Hi-Fi Products
Service Bulletin

Model: CDPC425

No. 381

Subject: A Whistling noise is heard when playing certain discs.

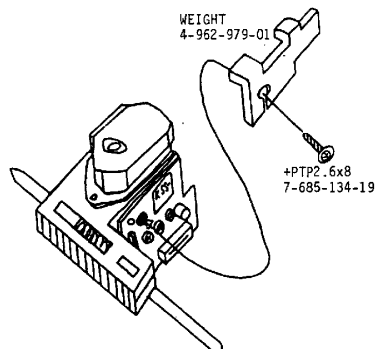
A whistling noise can be heard from the mechanical assembly. The whistling noise is a result of vibration of the disc, optical lens, and the BU base which results in resonance that causes the noise. This noise occurs only with certain discs.

To reduce the vibration of the BU base add the weight (4-962-979-01) to the optical block using a +PTP2.6X8 screw (7-685-134-19) in place of the original screw. See diagram below.
